July 12, 2022

RE: JMC Project 20044
4 Tripp Lane Gross Land Coverage Compliance Analysis
4 Tripp Lane
Town of North Castle, New York

Response to Town Consultant's Comments

GROSS LAND COVERAGE PLAN
 PEREIRA RESIDENCE
 4 TRIPP LANE
 NORTH CASTLE, NY

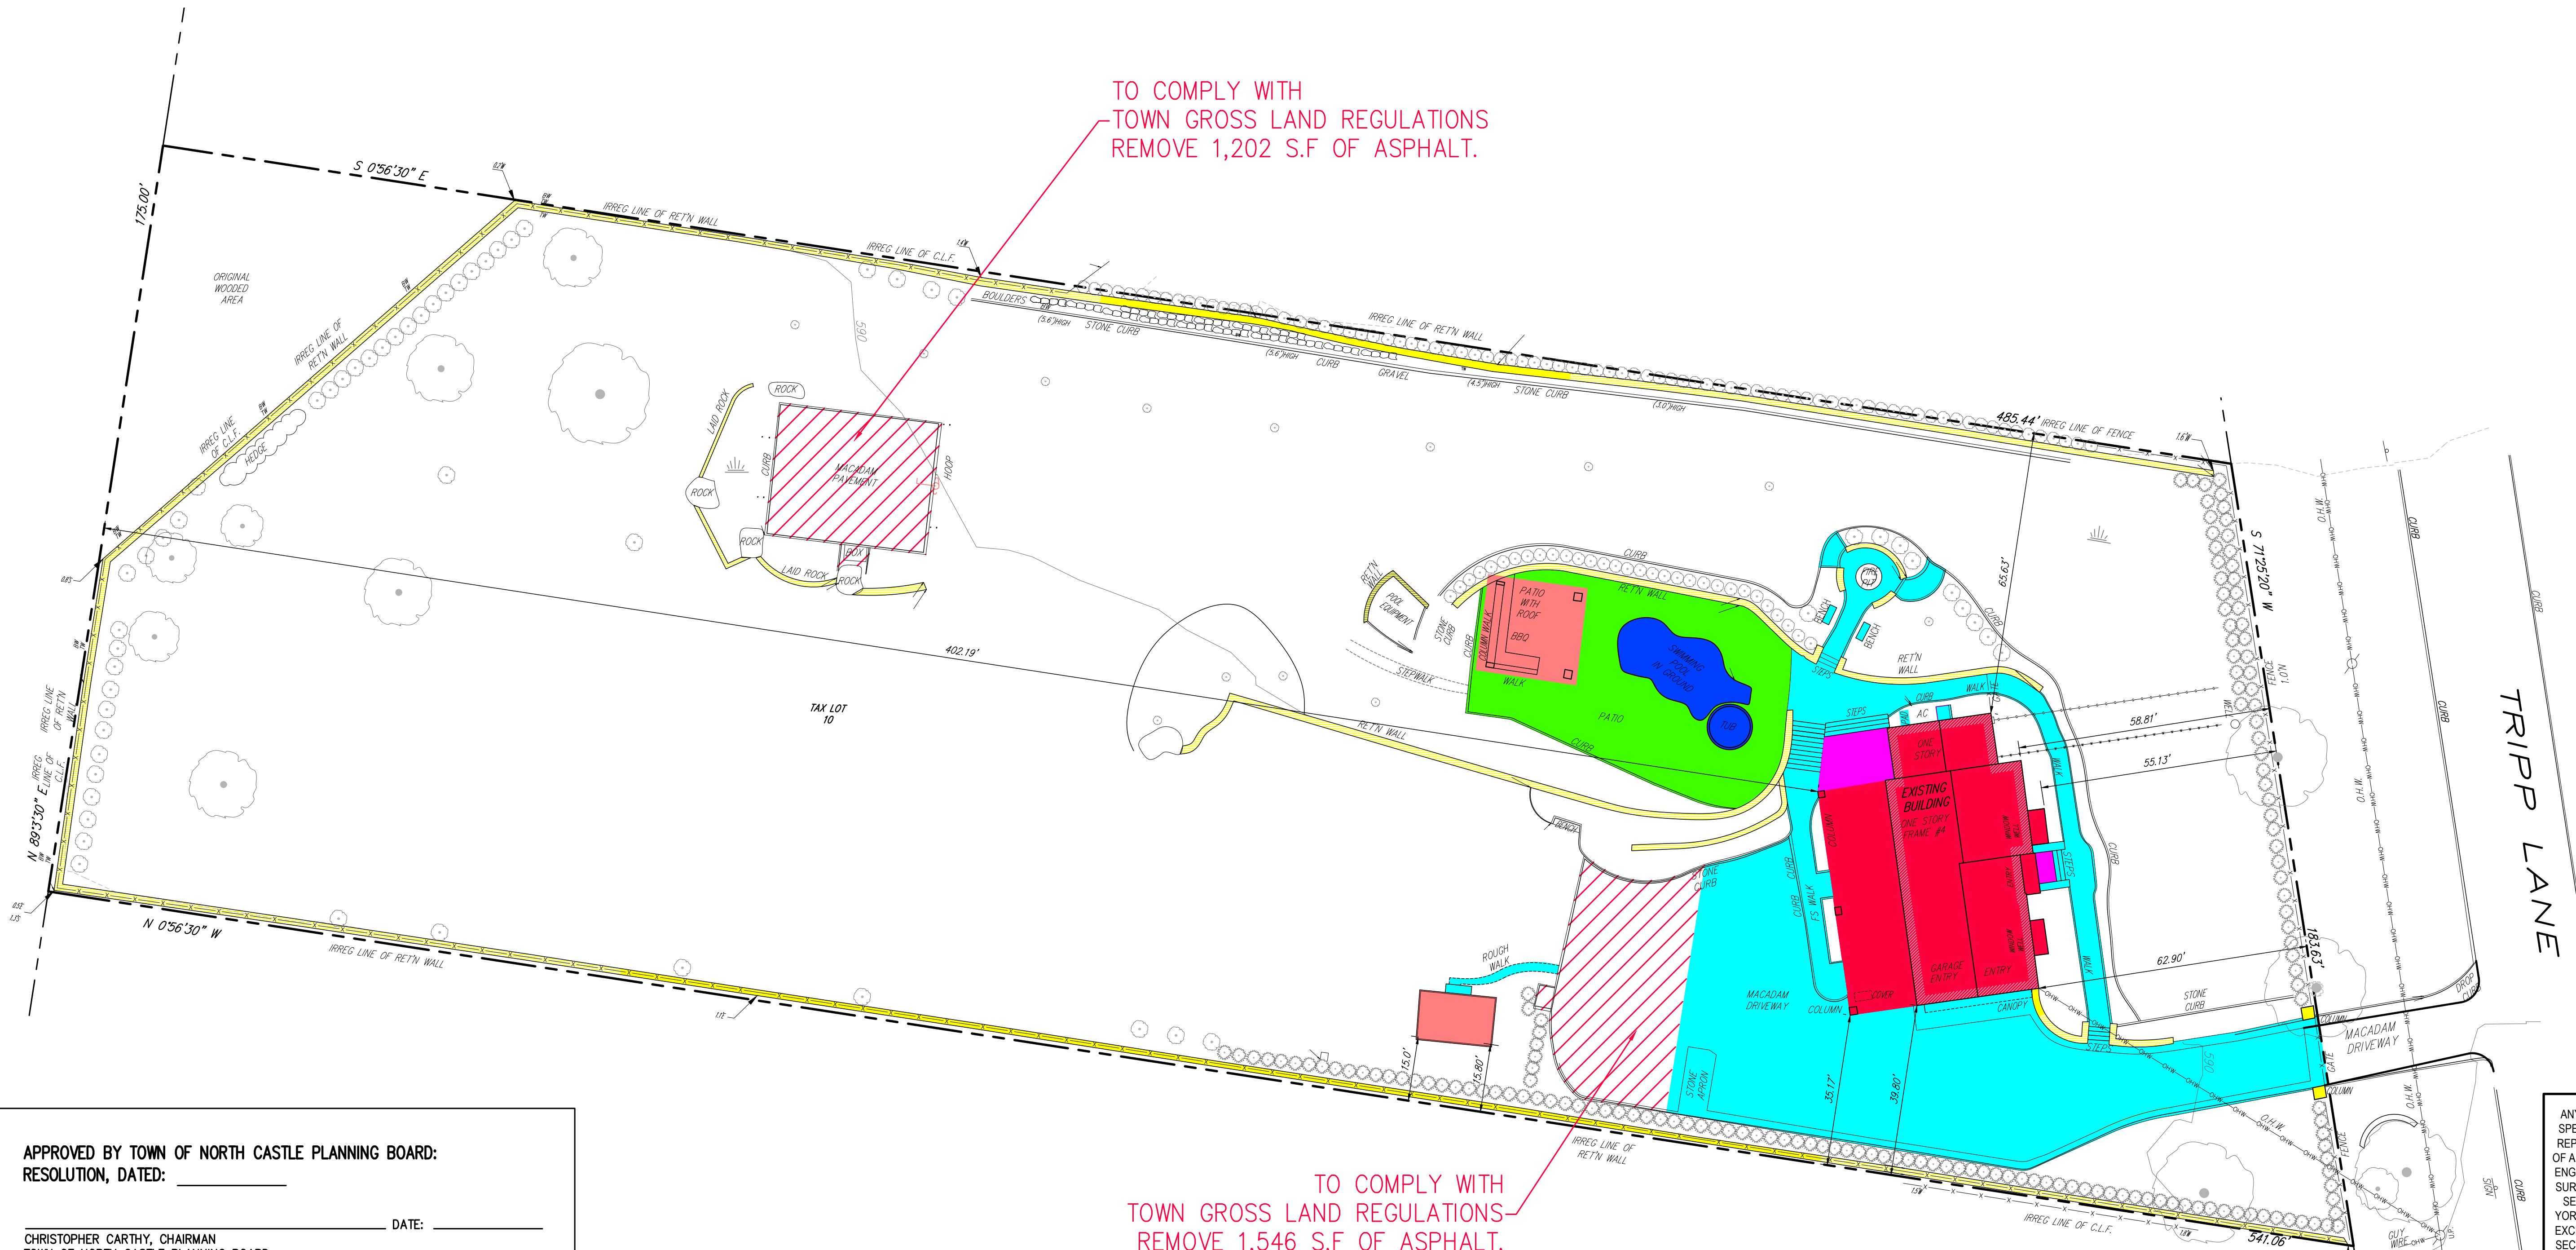
The applicant has provided a Gross Land Coverage Plan to demonstrate compliance with the maximum permitted gross land coverage for the zoning district. The plan indicates the removal of an existing sport court and a portion of the existing drive, both completed without permits, to reduce the land coverage, as necessary, to comply. We note, however, that the plan appears to require the addition of two areas of existing coverage, currently not accounted for; (1) the northernmost portion of the Boulder wall along the eastern property line appears to exceed 4 feet in height, and (2) the plan makes reference to a concrete patio north of the shed building. Although not shown on the plan, based on review of available Westchester County aerial mapping, the patio appears to exist. The plan shall be revised to include these additional coverage areas and the calculations adjusted accordingly so a determination can be made as to whether the total allowable coverage has been exceeded.

All portions (greater than 4' high) of the boulder wall have now been included in the coverage calculations. After a site visit by JMC on March 22, 2021, it was confirmed that the above referenced concrete patio area north of the shed building had previously been removed by the owner. A picture of this area has been included on the updated Gross Land Coverage drawing. In addition, the existing sport court and a portion of the existing driveway will be removed to comply with the Gross Land Coverage requirements.
